# NOTICE OF DECISION

## DECISION OF THE PLANNING ADMINISTRATOR

**SUBDIVISION / CLASS 1 ADJUSTMENT CASE NO.: SUB-ADJ19-02**

**REQUEST:** A consolidated application for a proposed 34-lot subdivision (Wren Heights) that the division of approximately 8 acres into 34 lots ranging in size from approximately 5,251 square feet to approximately 22,034 square feet. The applicant is requesting an alternative street standard for Earhart Street S and Felton Street S; in addition, a Class 1 Adjustment to reduce the minimum lot depth for Lot 7 from 120 feet, as required for double frontage lots under SRC 511.010(a), Table 511-2, to approximately 106-feet.

PROJECT NO.: 15128
PROJECT DATE: 05/20/2019
DESIGNER: THOMAS KAY COMPANY
CLIENT: SALEM, OREGON
SCALE: AS SHOWN
DRAWN: JMW
CHECKED: JMW
APPROVED: JMW
SHEET TITLE: TENTATIVE SUBDIVISION PLAN

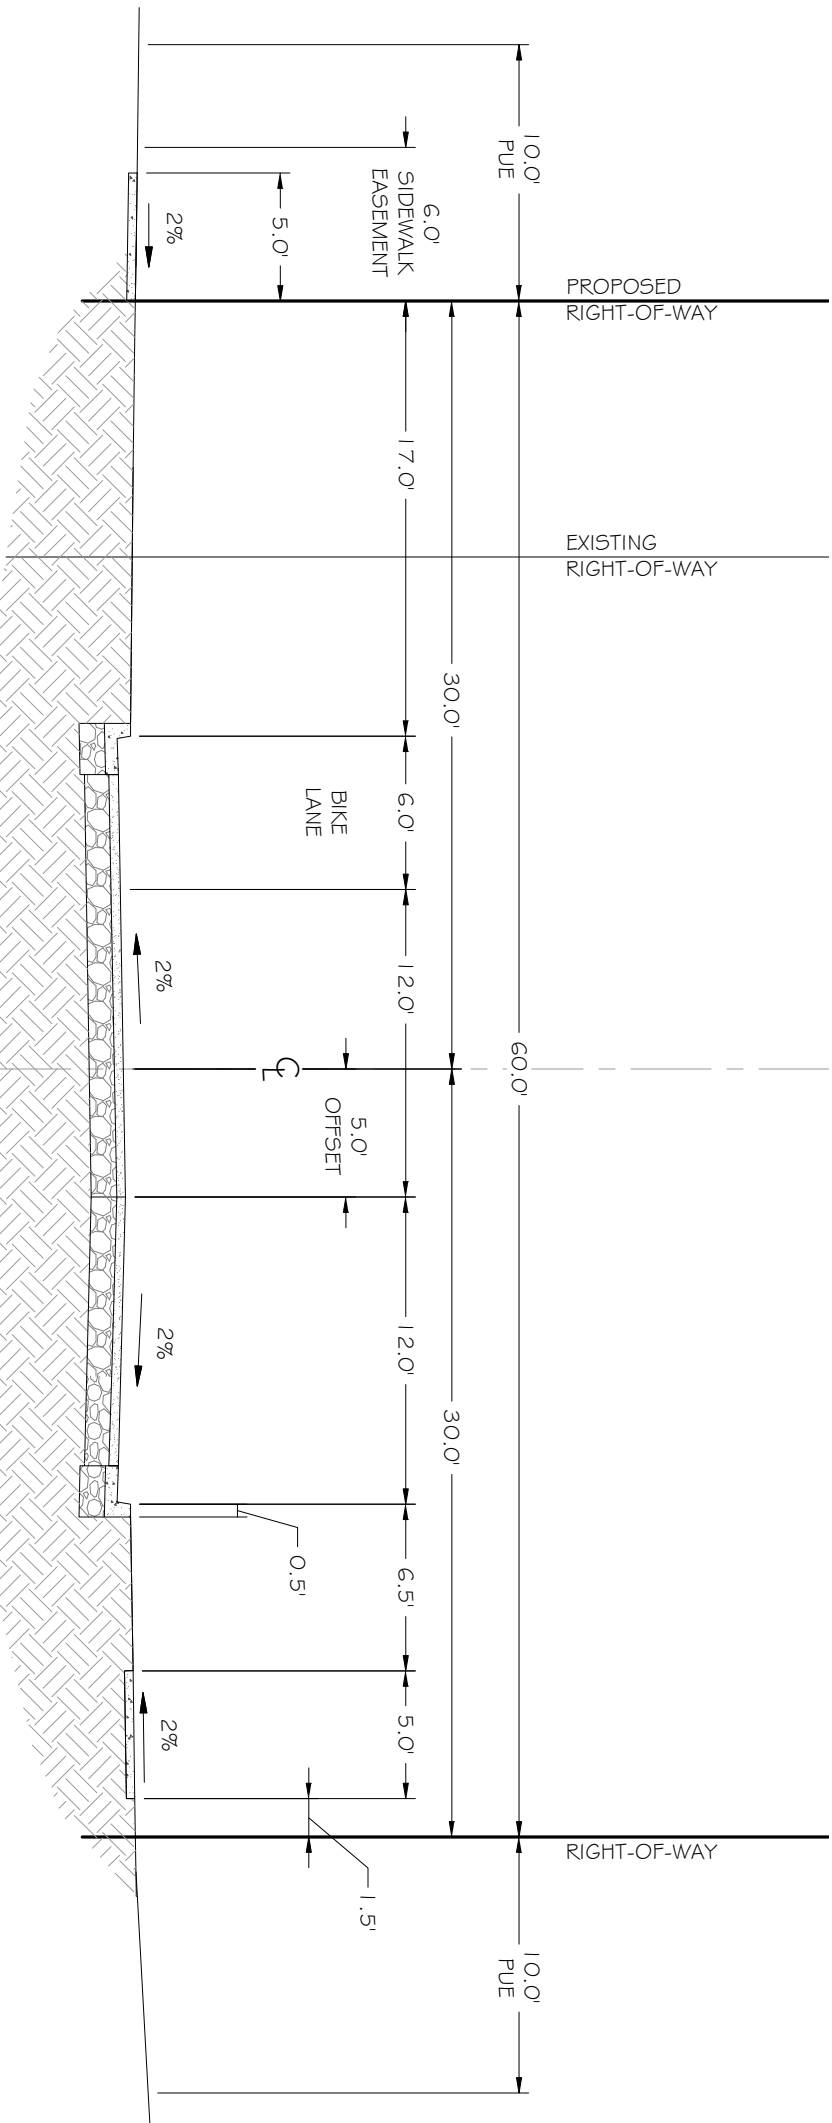
As shown on the applicant's tentative subdivision plan, the flag lot accessway serving Lots 4, 5 and 6 is approximately 180 feet in length, and located within a 25-foot wide easement, in conformance with the standards for flag lot accessways serving up to four lots. Because the flag lot accessway is greater than 150 in width, a turnaround is

Subsection (c) establishes standards for flag lots and flag lot accessways. Pursuant to SRC Chapter 800, Table 800-1, flag lot accessways serving 3 to 4 lots must be a minimum of 25 feet in overall width and must be paved to a minimum width of 20 feet. The accessway is proposed to serve Lots 4-6. Lots 1-3 abut the accessway and if used would exceed the allowed amount of lots to be served. The tentative plan show an easement width of at least 25-feet wide, with a 20-foot paved width. To ensure the standard is met the following condition shall apply:

- The applicant is requesting an alternate sidewalk location for the west side of Felton Street S along the north/south portion, to allow for curblin sidewalks pursuant to SRC 803.035(l)(2)(B). The applicant has not provided adequate evidence that an alternative street standard is needed. The applicant shall be required to construct the sidewalk so that the back of walk is located 28.5 feet from centerline pursuant to the Local street standard. Additional right-of-way is located behind the proposed sidewalk location to provide for transition to existing grade.

- Condition 2:** The flag lot accessway shall be paved in accordance with the requirements of SRC 800.025(c), Table 800-1. "NO PARKING—FIRE LANE" signs shall be posted on both sides of that segment of the flag lot accessway that is a fire apparatus roadway and "NO PARKING" signs shall be posted on both sides of any remaining portion of the accessway.

- Along the north/south portion of Felton Street S, the sidewalk shall be constructed so that the back of walk is located 28.5 feet from centerline pursuant to the Local street standard.
- The alternative cul-de-sac turnaround design at the terminus of Earhart Street S is authorized as proposed on the applicant's tentative subdivision plan.

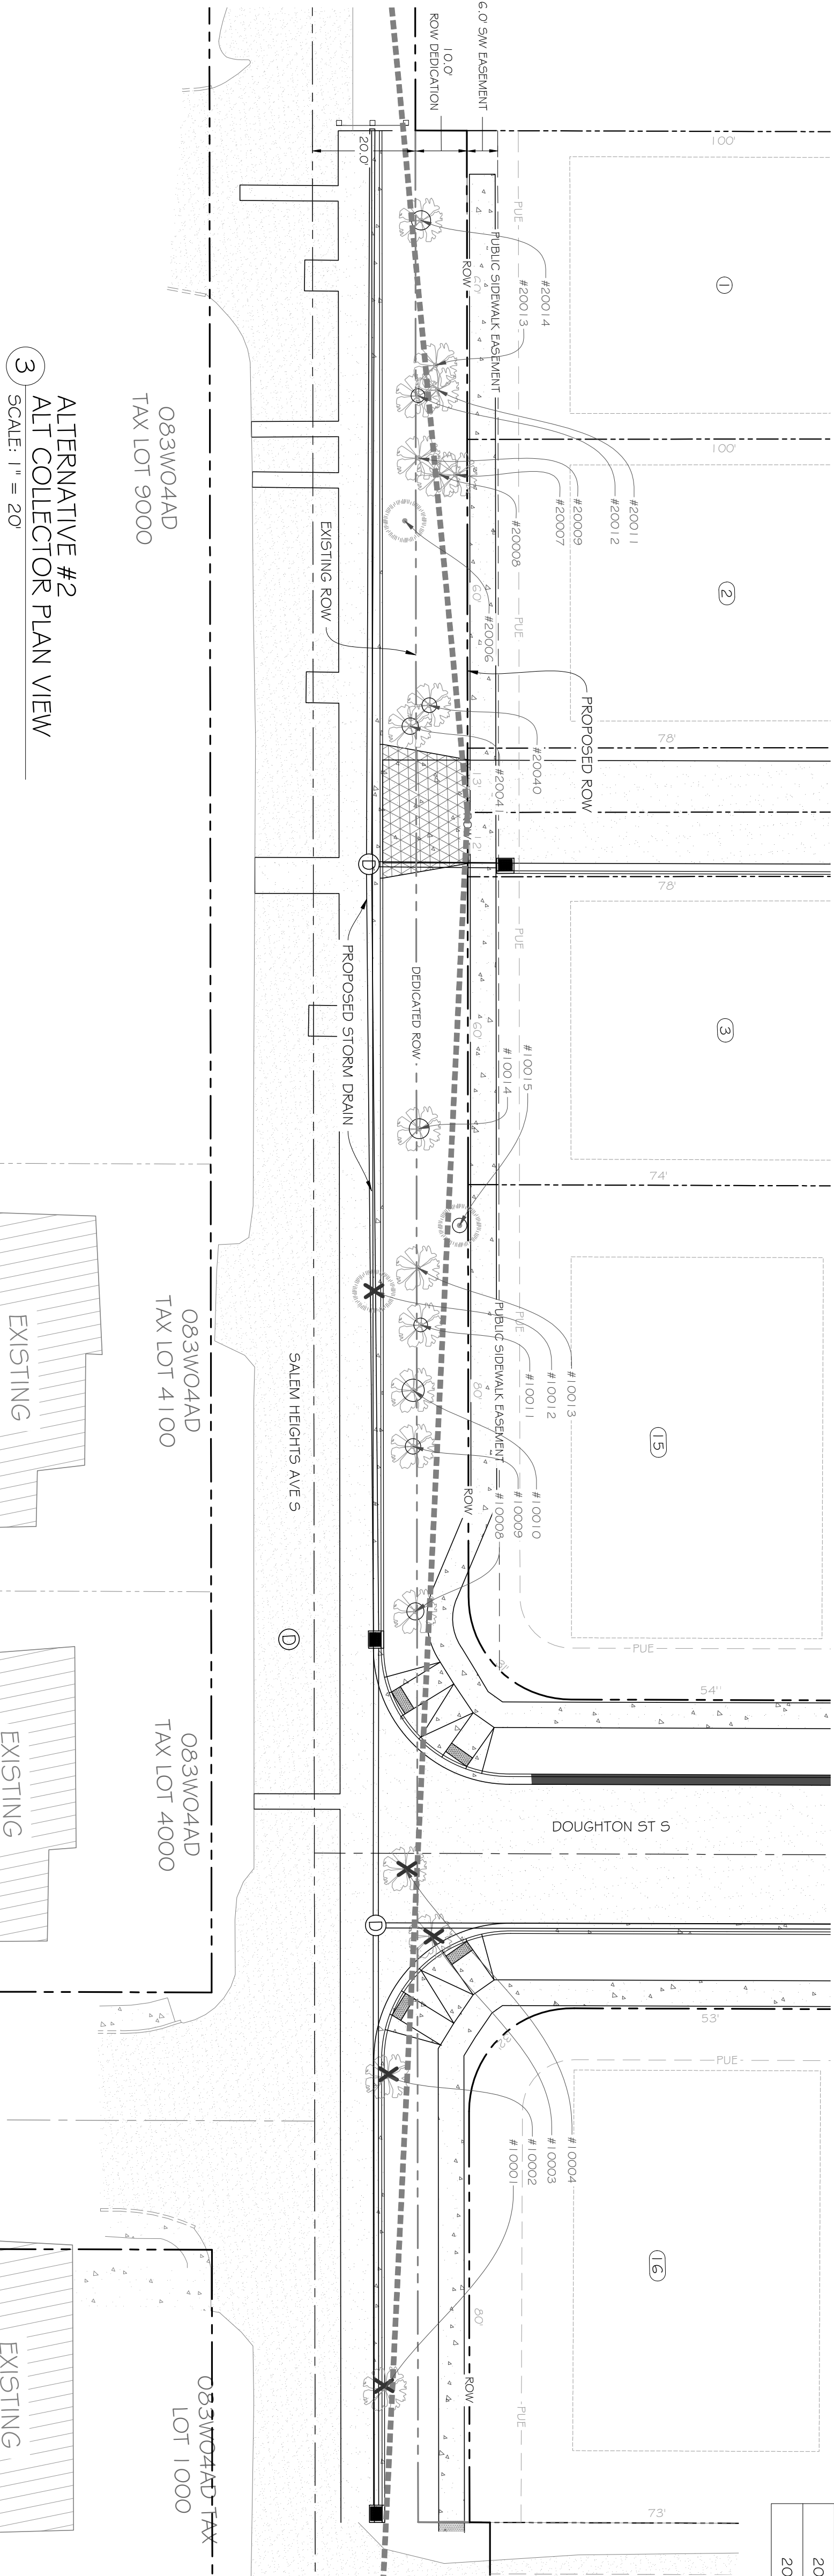
- Condition 8:** Prior to issuance of public construction permits, obtain final approval for tree removal permits for trees labeled as 10001 – 10004, and 10012 identified in the plan submitted on May 7, 2019 and titled Tree s within Right-of-Way Conservation Plan (Attachment C). Trees labeled as 10001 – 10004, and 10012 are tentatively approved for removal.

Street improvements along Salem Heights Avenue S may require removal of one or more street trees. The applicant has applied for removal of labeled 10001 – 10004, and 10012 on the plan attached (Attachment C). A Reasonable Alternatives Analysis pursuant to Administrative Rule 109-500-2.4 has been tentatively approved to remove trees labeled 10001 – 10004, and 10012. The approval is in conjunction with the proposed street improvements, and the sidewalk location north of trees proposed for preservation (trees labeled in Attachment C as 2006- 20009, 20011-

- Condition 9:** Prior to issuance of public construction permits, a tree preservation and protection plan pursuant to SRC Chapter 86 and Salem Administrative Rule 109-500, and signed by a certified arborist, shall be submitted for the identified preserved "Future Street Trees" (trees labeled as 20006- 20009, 20011- 2014, 20040, 20041, 10008 - 10011, 10013 – 10015, show on Attachment C), to the City for review. Future Street Trees, identified above, shall be preserved. Any proposed removal of identified Future Street Trees (listed above) would require a separate removal permit pursuant to SRC 86.090.

2. Prior to issuance of Public Construction permits, obtain tree removal permits for trees located within the right-of-way along the frontage of Salem Heights Avenue S. In accordance with the plan submitted on May 7, 2019 and titled Trees Within Right-of-Way Conservation Plan (C-1.17), trees labeled as 10001 – 10004, and 10012 are tentatively approved for removal. Any additional removal of street trees requires

3. Prior to issuance of Public Construction permits, a tree preservation and protection plan pursuant to SRC Chapter 86 and Salem Administrative Rule 109-500, and signed by a certified arborist, shall be submitted to the City for review and approval. In accordance with the plan submitted on May 7, 2019 and titled Trees Within Right-of-Way Conservation Plan (C-1.17), trees labeled as 10008 - 10011, 10013 – 10015, 20006- 20009, 20011- 20014, 20040, and 20041 are slated for preservation.
